GENERAL PROJECT REPORT FOR WELLINGTON ESTATES SUBDIVISION

REVIEW COMMENTS

FILE #MS-95-78

TITLE HEADING: Wellington Estates Subdivision

WELLINGTON ESTATES SUBDIVISION SITE PLAN

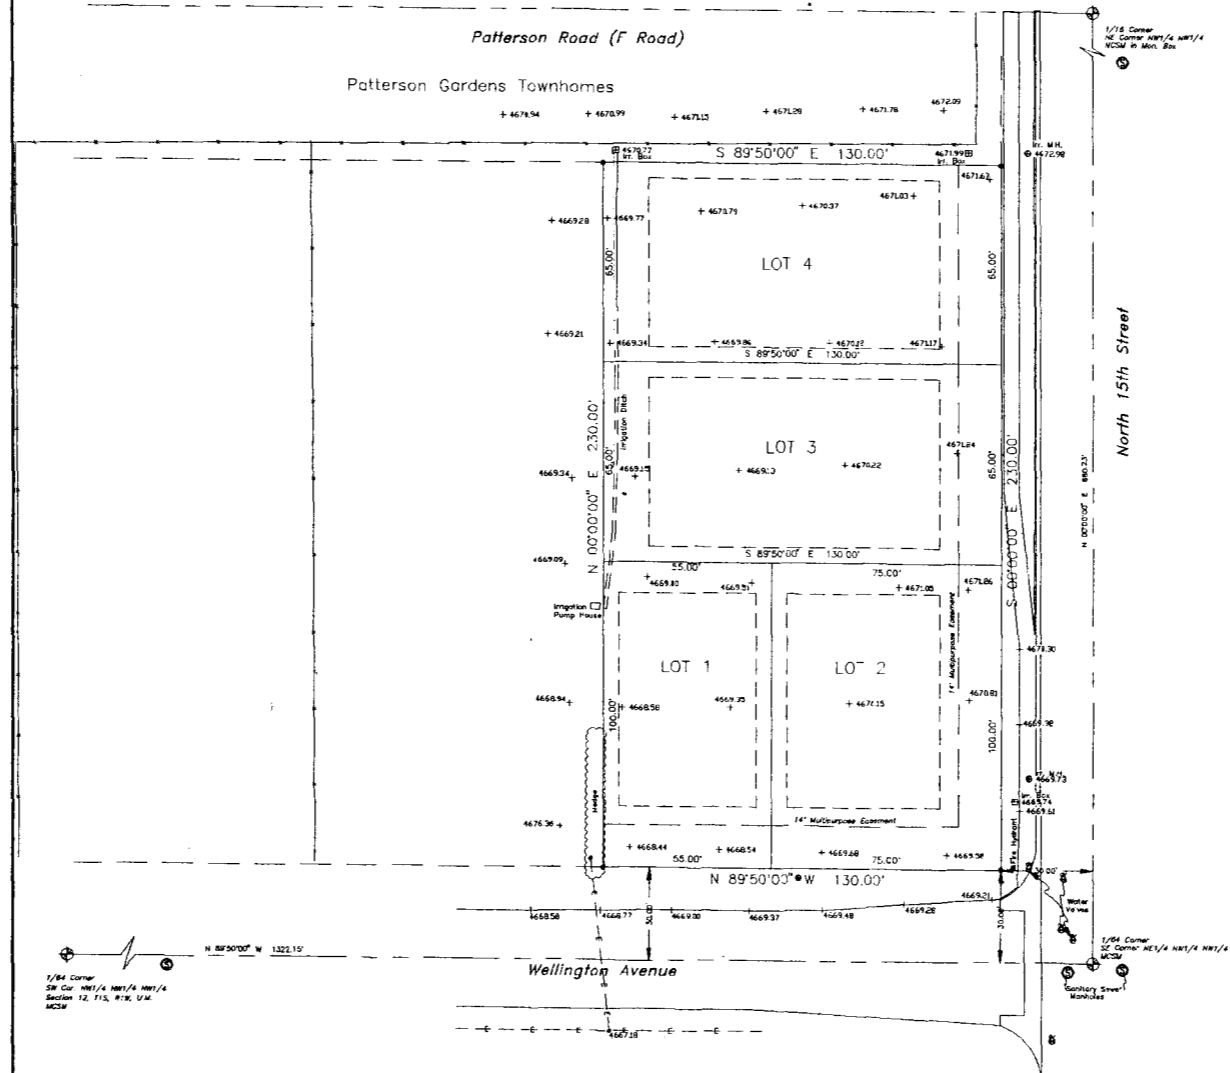
1. Access to 15th Street is limited to one common access and driveways for the residences must be designed such that backing out into 15th Street does not occur.
2. Drainage Fee = \$2082.37
3. Transportation Capacity Payment applies at time building permit issuance.
4. The plat dedication language includes some statements which do not appear necessary such as Street Dedications, Utility and Irrigation Easements.

1. See notes on attached plat (dedicatory changes needed) that need correction.
2. Need proof of Homeowners Association formation and mechanism to operate and collect for irrigation system (including forced assessments as lien on property).

1. In the dedication, utility and irrigation easements are addressed but not shown on the plat, and in the last all easements statement, the last sentence contains verbage that may not need to be there.
2. Label section, township & range for the SE COR, NENW, NW and for the NE COR, NWNW
3. Label P.O.B. and Basis of Bearings on plat
4. Change Basis of Bearings S00°00'00"E to N00°00'00"E

SEWER: City
1. Please show location of water and sewer taps.

2. The Final Plat dedication language has been modified.

1. The dedication statement on the Final Plat has been modified.

Requested modifications have been added to the Final Plat.

The location of proposed water and sewer tap locations have been added to the Site Plan which has been transmitted to the Community Development Department.
